From: Jason Burch, Director of Air Service & Marketing
Charlottesville-Albemarle Airport Authority

Subject: ADDENDUM #3 – Questions and Answers
Request for Proposals: Airport Flight Information Display System, Media Management System, Baggage Claim Announcement System and Public Address System Services.

***** TERMINAL LAYOUT ON PAGES 12 AND 13 *****

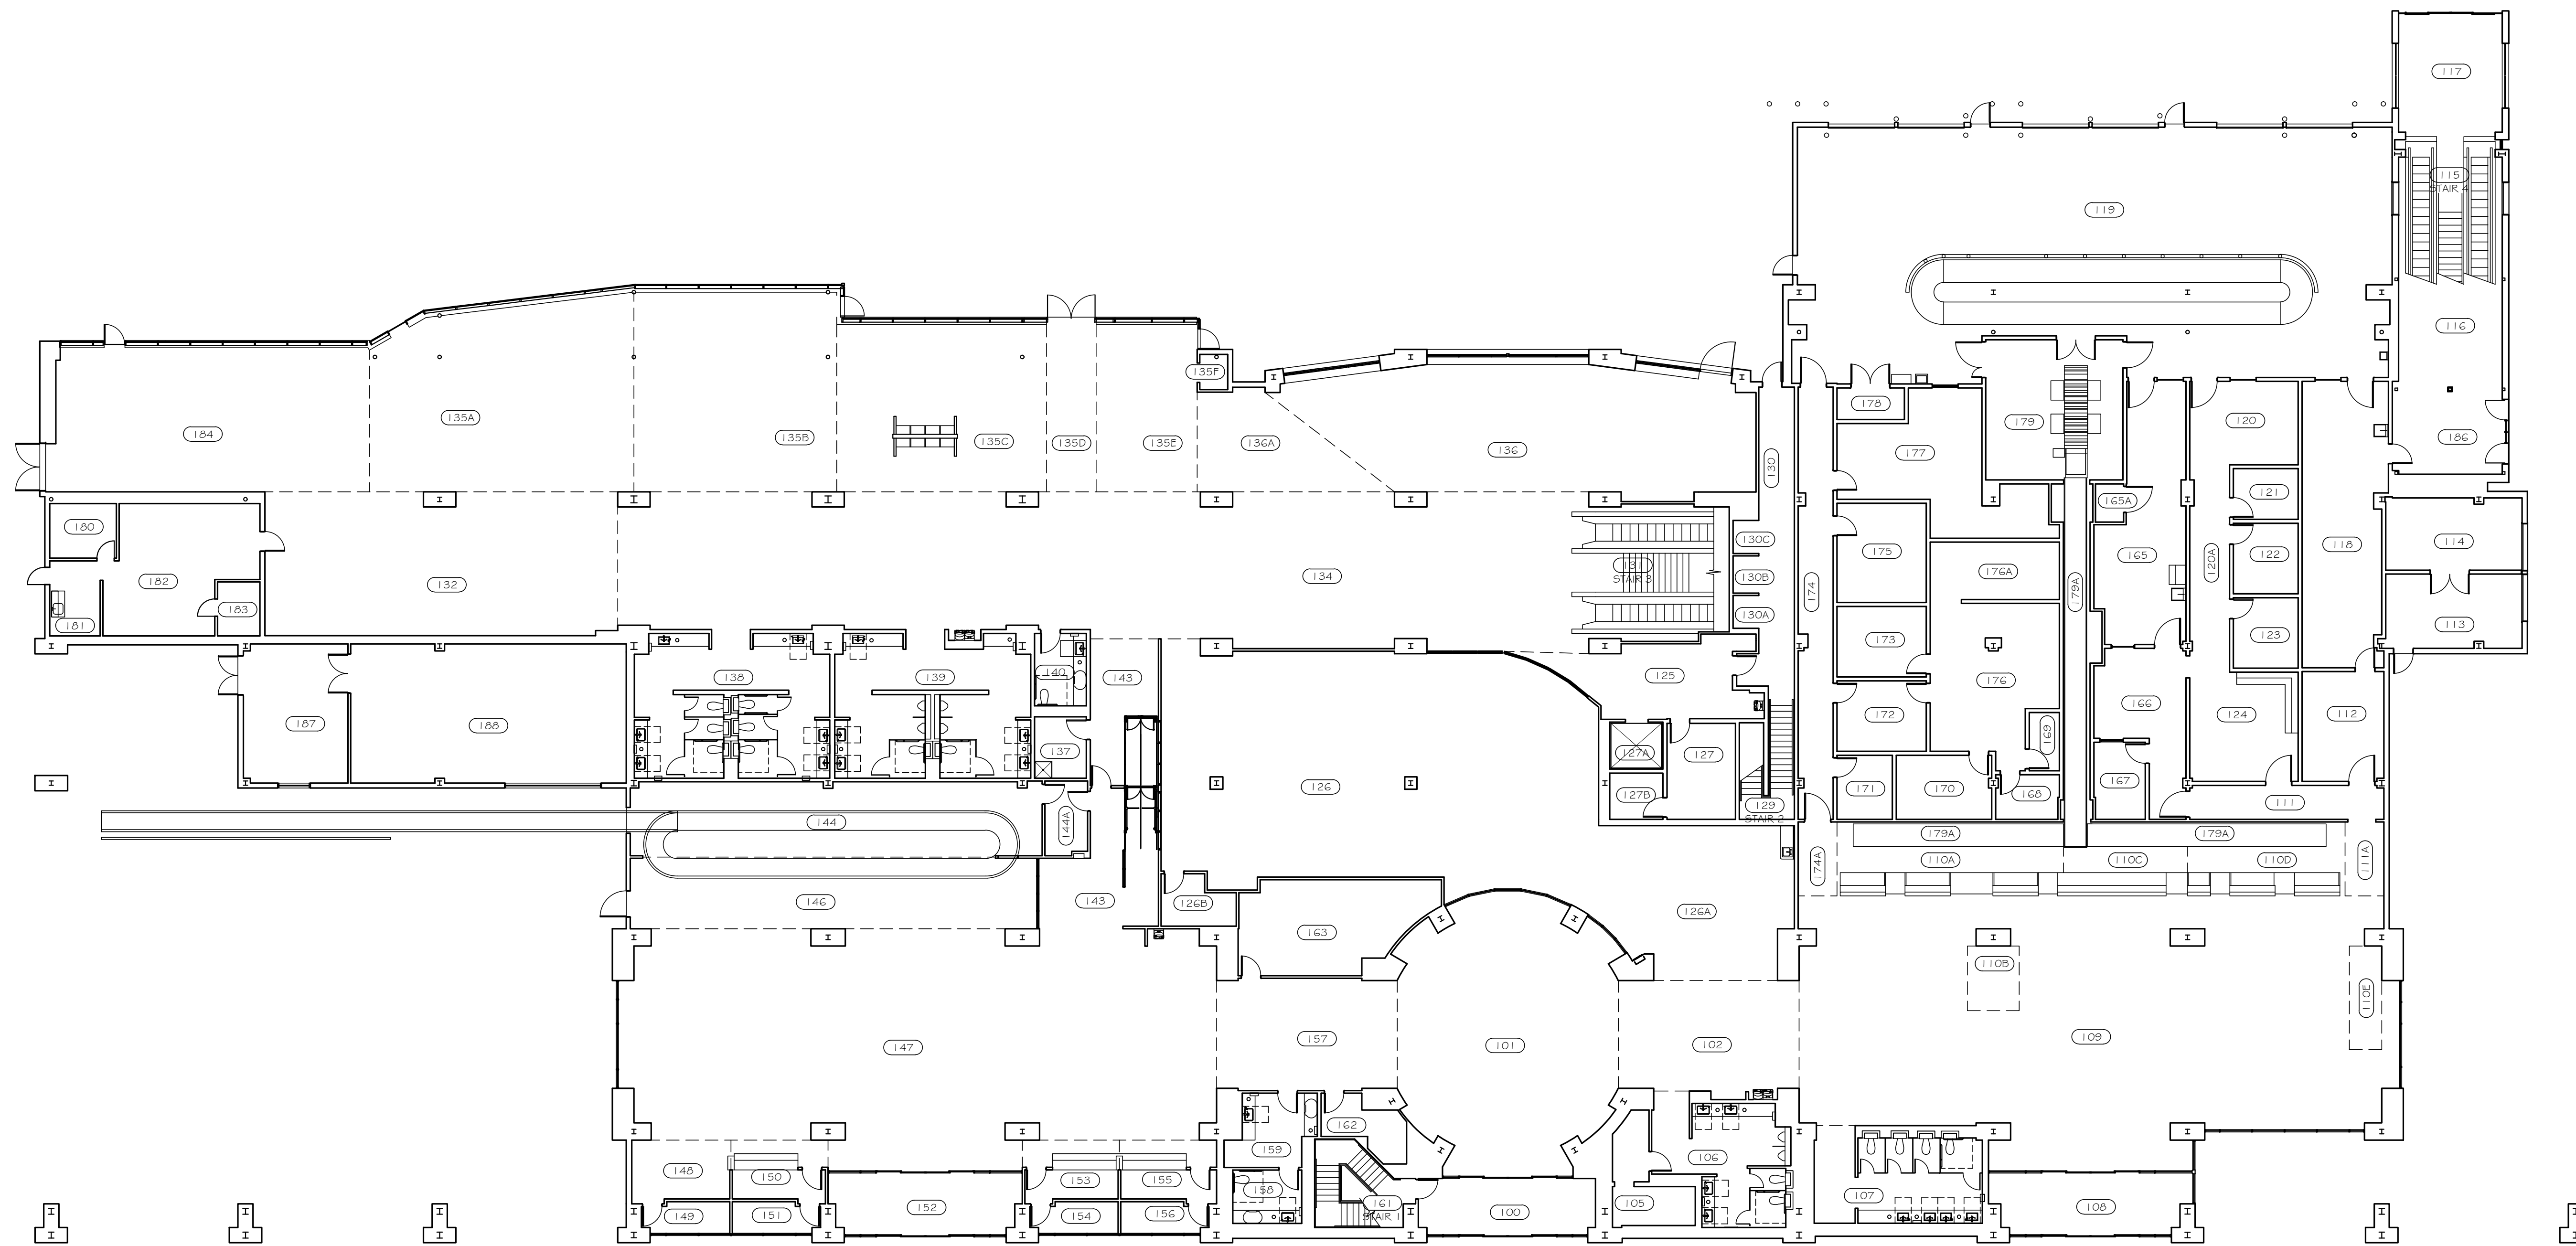
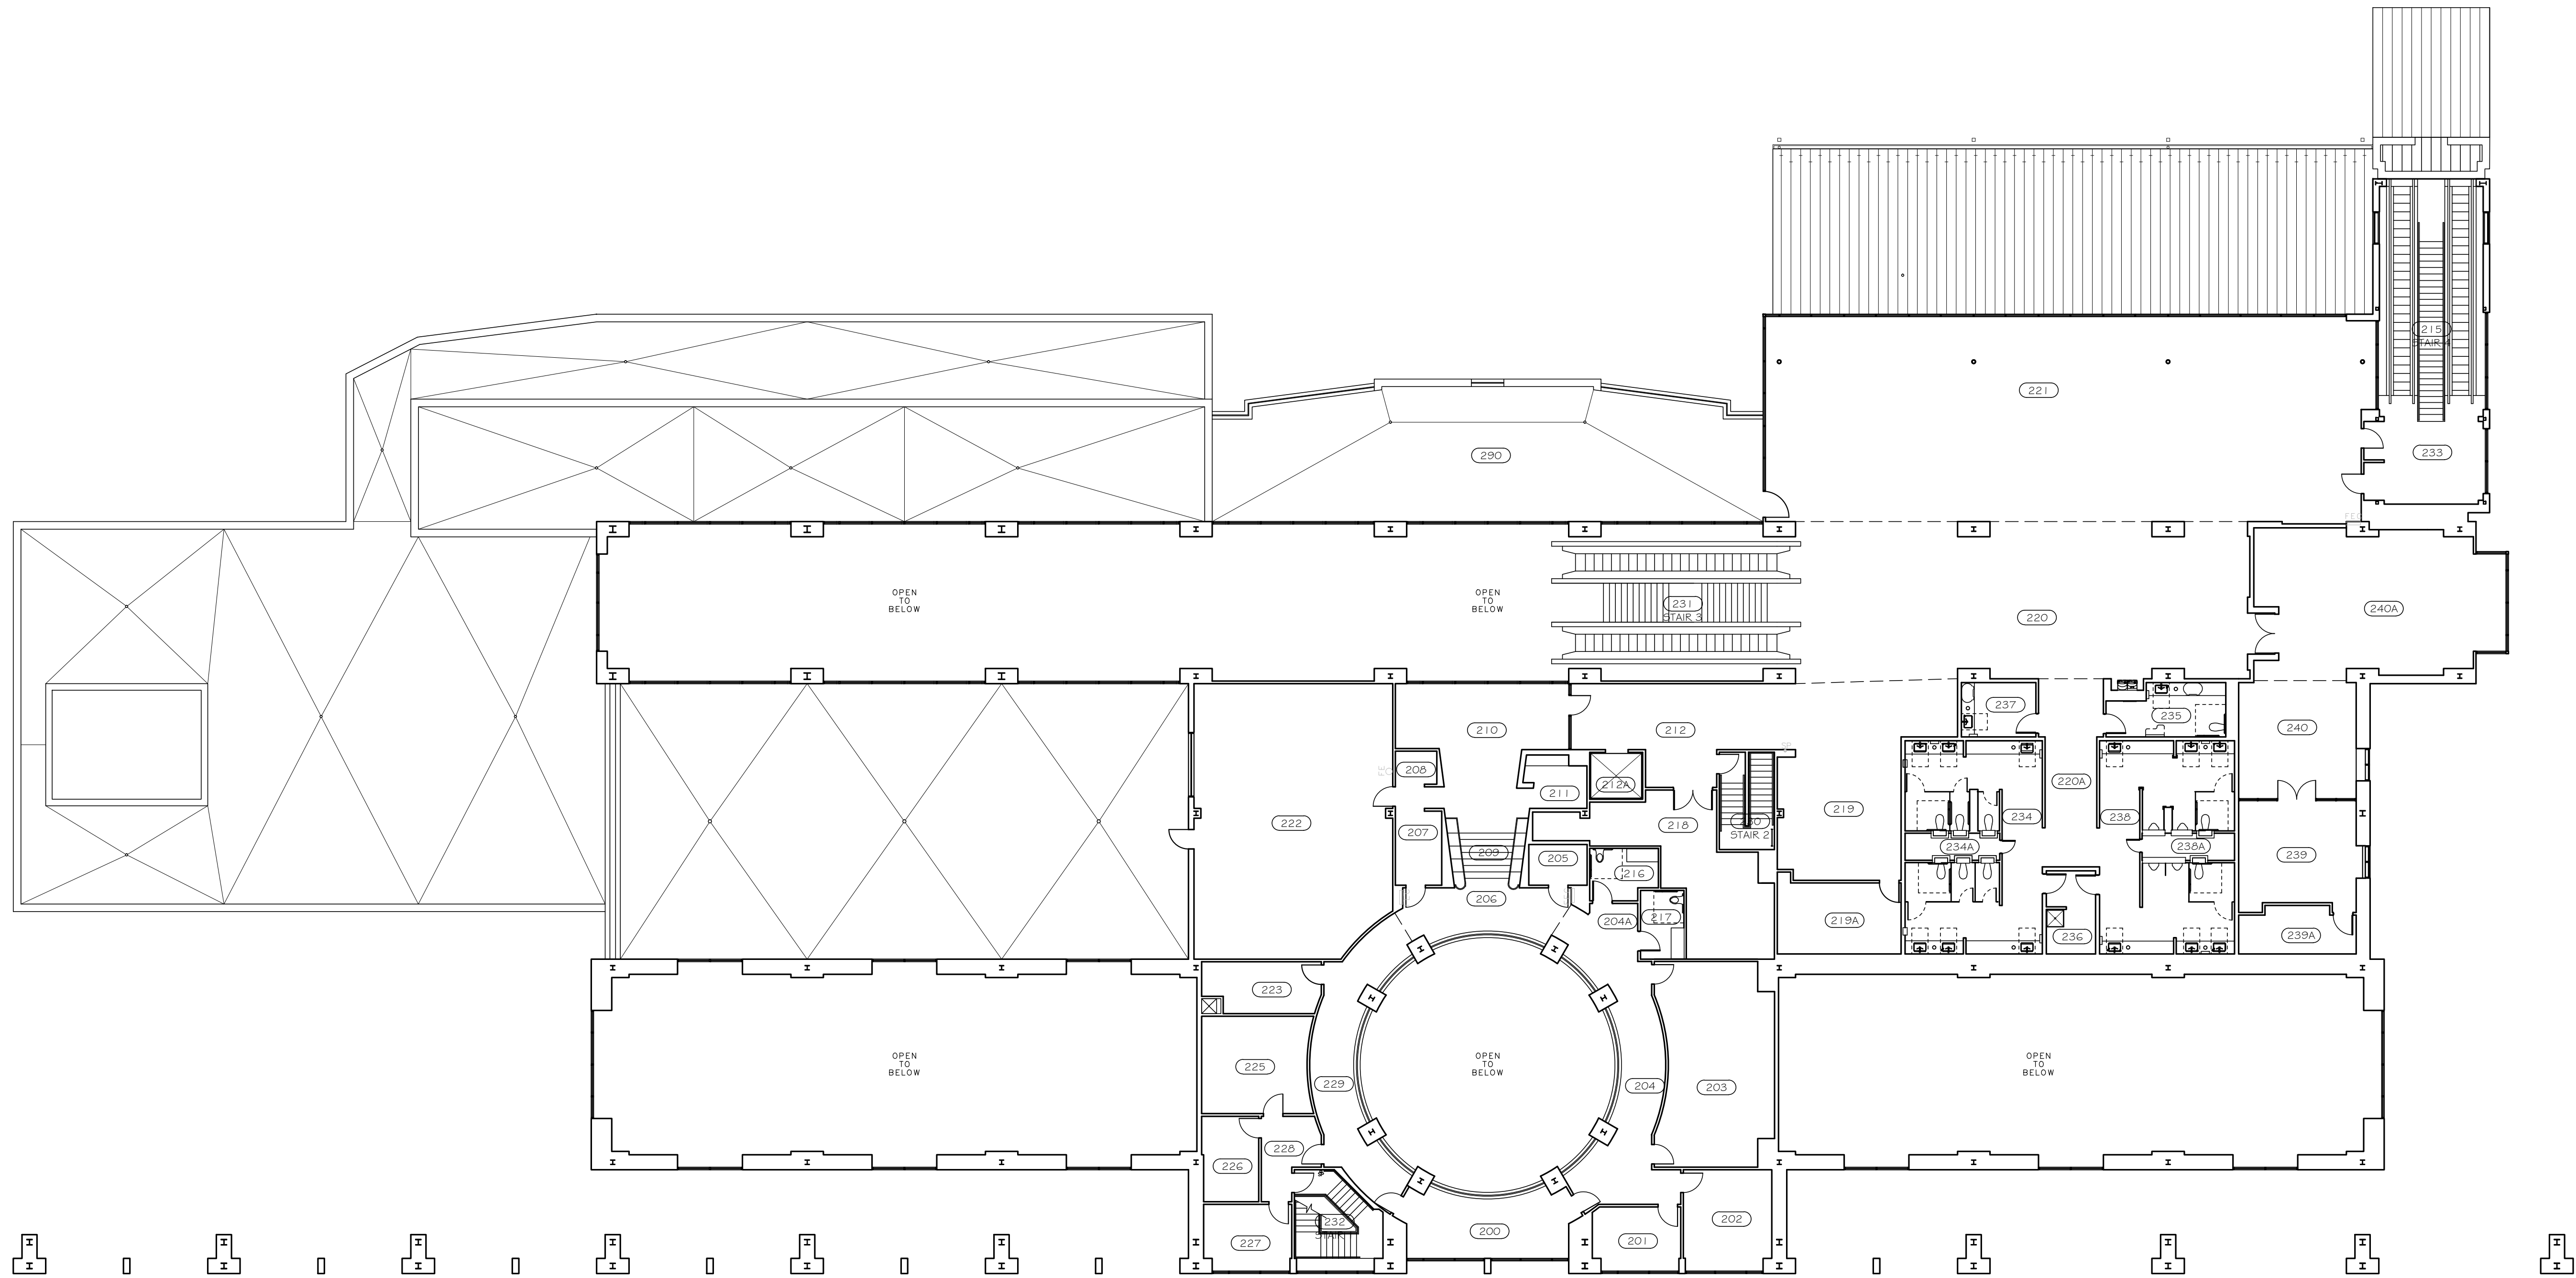
61. Can Charlottesville-Albemarle Airport Authority provide a map or drawing of the locations of the displays?

62. Does the Airport Authority have a zone layout for audio paging?

80. Can CHO provide drawings of the existing public-address amplifiers and speaker locations?

Answer: We have provided a terminal layout in this addendum, however, locations of the displays are subject to design per the RFP. Please see pages 12 and 13 of this addendum.

Answer: We have provided a terminal layout in this addendum, however, zone locations are subject to design per the RFP. Please see pages 12 and 13 of this addendum.

Answer: We have provided a terminal layout in this addendum, however, locations of speakers and PA amplifiers are subject to change based on the RFP’s mention of design and installation support. Please see pages 12 and 13 of this addendum.
